TECHNICAL MEMO

To Linda Riley
From Biljana Rajlic
Date April 3, 2012
Project # 285380
Reference Tunnel watertightness
Page 1 of 18
CC

285380-03-126-0039 Document Revision Summary

PART 1 – ORIGINAL TUNNEL WATERTIGHTNESS MEMO (REV A)

Figure 1: Drains in a typical WEP tunnel abutment

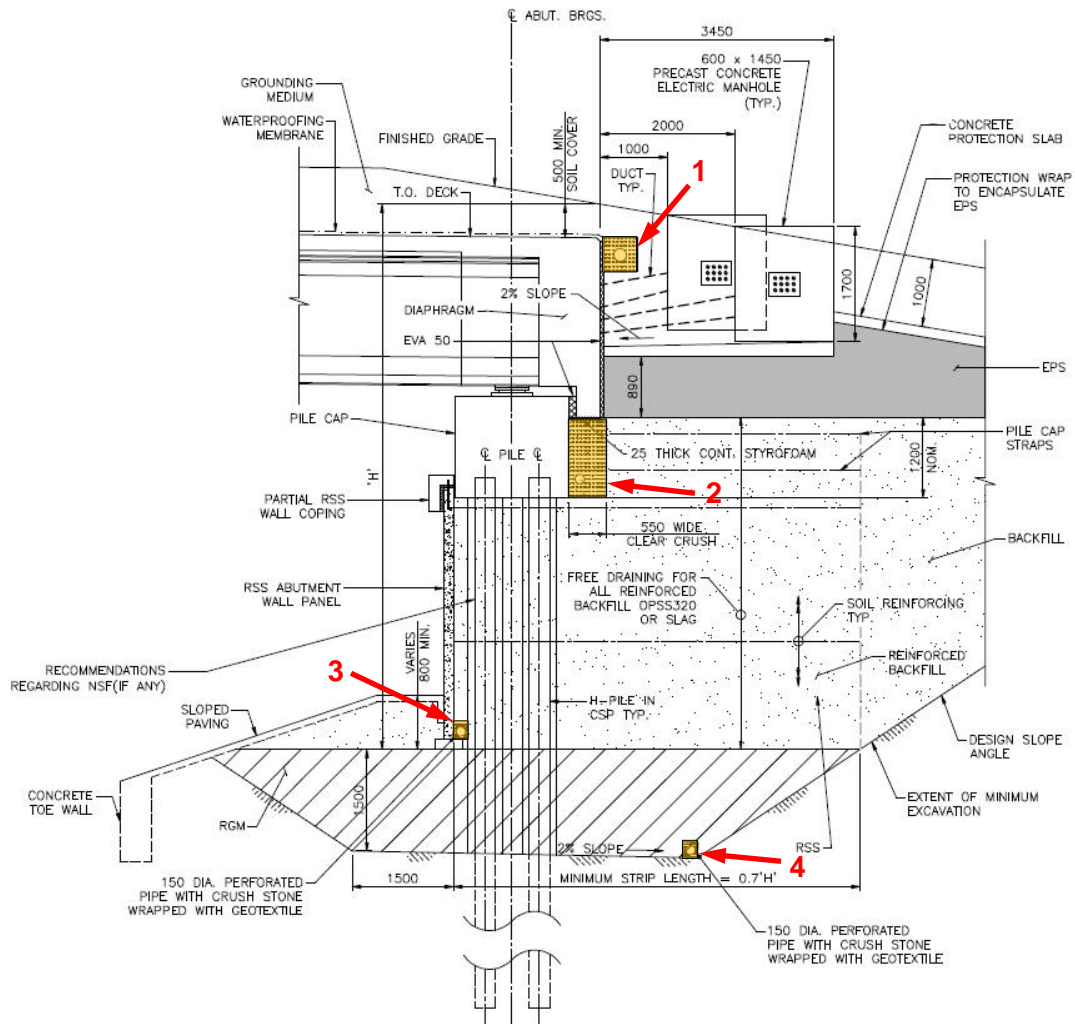
HMQ comment: "HMQ would consider the four (4) lines of subdrains identified in Section 4 of PIE's memo (enclosed with PIC's letter) on their own to be non-compliant as the EPS could act as an impervious layer thus causing water to build up behind the abutment."

1. HMQ would consider the four (4) lines of subdrains identified in Section 4 of PIE's memo (enclosed with PIC's letter) on their own to be non-compliant as the EPS could act as an impervious layer thus causing water to build up behind the abutment. Please propose a solution to address this issue.

Since the issue of revision A of this memo, the precast concrete manholes have been removed from this location. The removal of the electrical manholes means that there is no longer the potential for water to be trapped in the lowered portion of EPS, as was shown in Figure 1 of revision A.

Figure 3: Layout of drains in a typical tunnel. Abutment drains have outlets to the storm sewer catchbasins, which are indicated here as green squares.

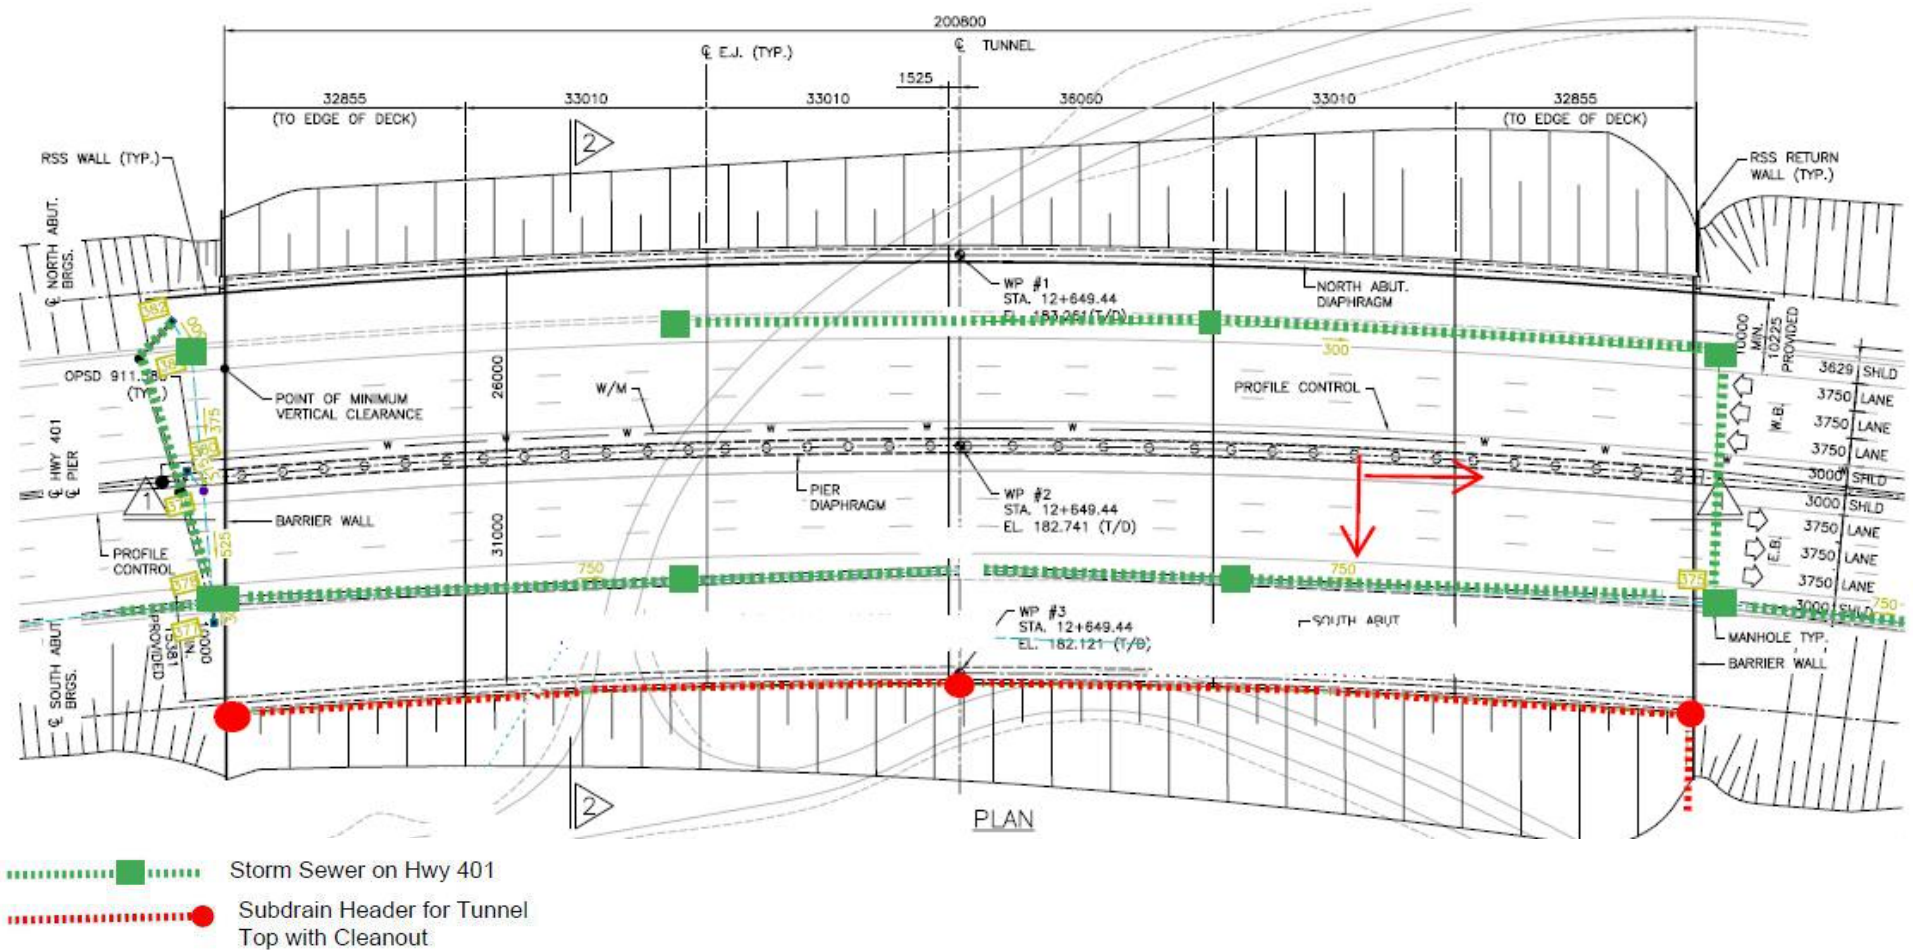
HMQ comment: "...As each of the 5 lines of subdrains has a specific purpose for the drainage of a specific area of the structure, the subdrain system may not provide sufficient redundancy in the event that one or more pipes become blocked. WEMG should propose a means of monitoring the performance of the subdrain system and removing any plugs. Further detail should also be provided for the "Cleanouts" shown in Figure 3."

3. With respect to the 5th paragraph in Section 4 of PIE's memo, the term 'well-graded material' infers some percentage of fines, which can clog the subdrains. As each of the 5 lines of subdrains has a specific purpose for the drainage of a specific area of the structure, the subdrain system may not provide sufficient redundancy in the event that one or more pipes become blocked. WEMG must propose a means of monitoring the performance of the subdrain system and removing any plugs. Further detail should also be provided for the "Cleanouts" shown in Figure 3 of the memo.

WEMG is of the opinion that the subdrain system will provide sufficient redundancy in the event that one or more pipes become blocked. The system is to be installed according to the requirements of OPSS 405, and the subdrains will have sufficient slope for the water to drain properly.

Inspection of the subdrains will be part of the detailed structures inspection that is specified to happen every year. Any blockages should be minimal but will be identified through the normal inspection process.

Further detail for the "Cleanouts" has now been provided in the Highways design submissions. Typical details are shown in Figure 9.

Figure 10: Abutment joint seal (extract from Structures design submission)

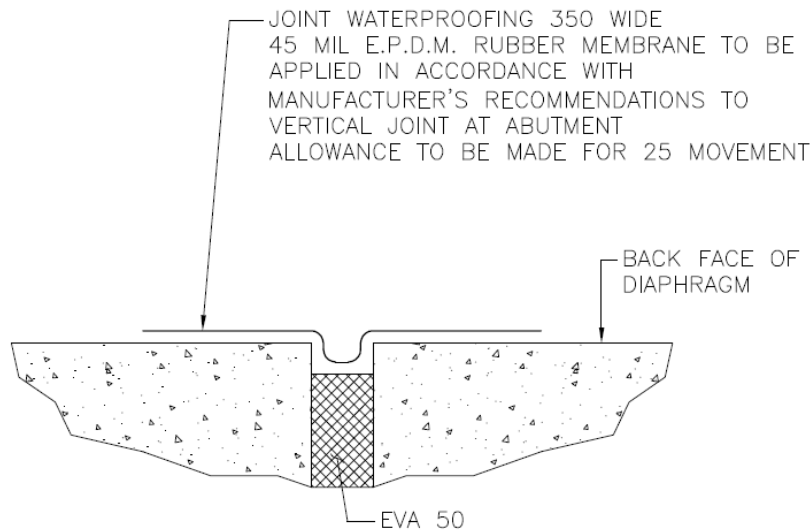
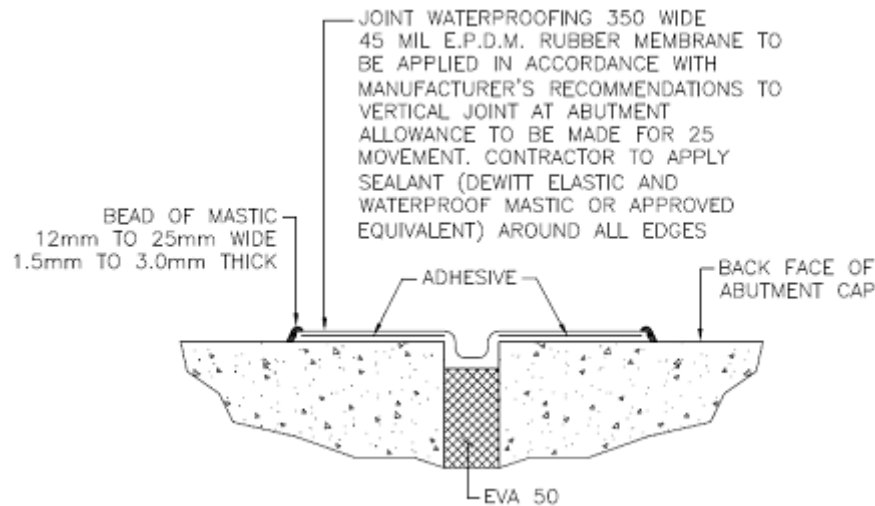
HMQ comment: "...the edges of the rubber membrane should be sealed to prevent the ingress of water between the concrete and the membrane."

4. The proposed details at abutment joints referenced in Section 5 of PIE's memo are in general conformance with OPSD 3950.100, November 2005. The only comment to be directed to WEMG with respect to the abutment joints is that the edges of the rubber membrane should be sealed to prevent the ingress of water between the concrete and the membrane.

WEMG fully agrees with this comment, and Tunnel drawings will specify that the rubber membrane be fully sealed to the concrete surface with an appropriate adhesive system around all edges, as shown in Figure Figure 10.
